X.X X.XX		316 Stainless	End Post, Stainless Steel, 2.00 Inch Square x 0.12 Inch Wall, 42 High, Brushed Satin Finish, Grade 316, Embed Mount, Flat Plate		
X.XXX	= ± .010	Satin Brushed  WEIGHT:	9/5/2019 DRAWN BY: T. Kolbach	2	> WAGNER
UNLESS OTHE	RWISE NOTED	N/A	LG32242DEEM.4		COLLABORATIVE METAL WORKS

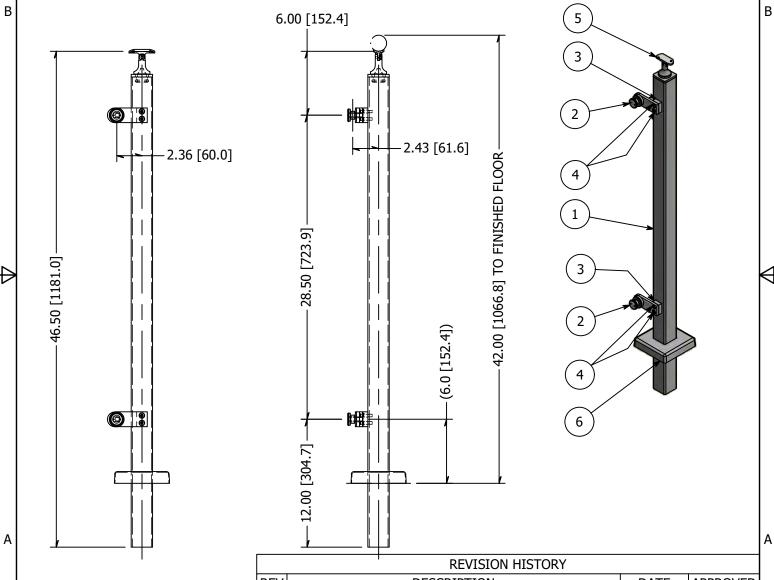
REVISION HISTORY					
RE	V DESCRIPTION	DATE	APPROVED			
	Wall Thickness was changed from 0.25 to 0.12 and the					
2	corner radii from .375 to .188 on the square post.	3/13/2019	ATM			
	ADDED (1) ITEM 6 (P/N LG322SMC)
